Access Compliance Report Public Rights-of-Way (Curb Ramps)

Intersection ID: 11231	Main Street: W_4TH_ST_EXT	Cross Street: WALNUT_AV	Location: E
ADA ID: 8DA698AAA389	Ramp Type: BlendTrans1	Initial Pass/Fail: Fail	Overall Compliance: No Severity Score: 12.5

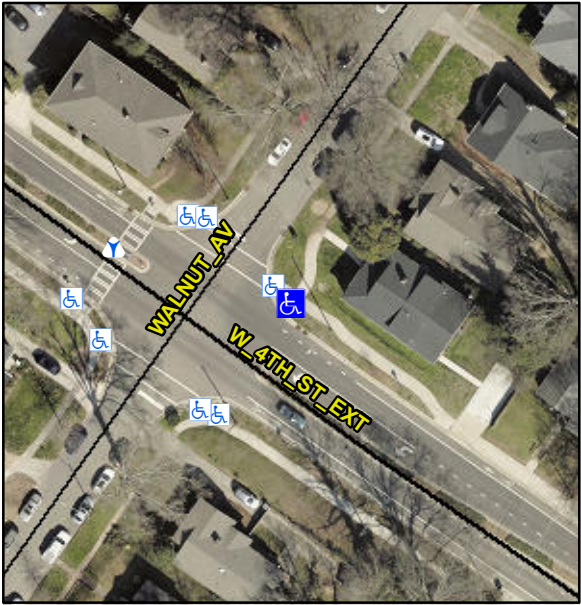
PROW/ADA:
R304.5.3

Compliance	Description	Data	Compliance	Description	Data
N/A	Ramp Length (in)	64.0	Yes	BlendTrans Slope (%)	1.0
Yes	Ramp Width (in)	71.5	No	BlendTrans XSlope (%)	5.8
N/A	Flare Type LT	N/A	N/A	Flare Type RT	N/A
N/A	Flare Slope LT (%)	N/A	N/A	Flare Slope RT (%)	N/A
N/A	Flare Traversable LT?	N/A	N/A	Flare Traversable RT?	N/A
N/A	Landing Length (in)	N/A	N/A	DWS Provided?	N/A
N/A	Landing Width (in)	N/A	N/A	DWS Contrast?	N/A
N/A	Landing Slope (%)	N/A	N/A	DWS Length (in)	N/A
N/A	Landing X Slope (%)	N/A	N/A	DWS Full Width?	N/A
N/A	Landing Curb? (Y/N)	N/A	N/A	DWS Offset (in)	N/A
N/A	Shared Landing?	N/A			
N/A	Gutter Ponding?	N/A	N/A	Gutter Slope (%)	N/A
N/A	Gutter Lip Ht (in)	N/A	N/A	Gutter X Slope (%)	N/A
N/A	Painted X Walk1?	No	N/A	Painted X Walk2?	N/A
	X Walk 1 Direction	To SW		X Walk 2 Direction	N/A
	X Walk 1 Width (in)	N/A		X Walk 2 Width (in)	N/A
	X Walk 1 Slope (%)	3.4		X Walk 2 Slope (%)	N/A
	X Walk 1 X Slope (%)	3.6		X Walk 2 X Slope (%)	N/A

N/A	Ramp inside XWalk1?	N/A	N/A	Ramp inside XWalk2?	N/A
	Road Slope (%)	3.6		Clear Space?	N/A
	Road X Slope (%)	3.4	N/A	Clear Space to XWalk (in)	N/A
N/A	Any Obstructions?	N/A	N/A	Storm Grate/Utility Hazard?	N/A
	Obstruction Type			Storm Grate/Utility Type	
		N/A			N/A
			Yes	Surface Condition? (G/P)	Good
			N/A	Curb Slope (%)	1.7

Possible Solutions:
Remove & Replace Curb Ramp With Two New Directional Ramps or Equivalent.
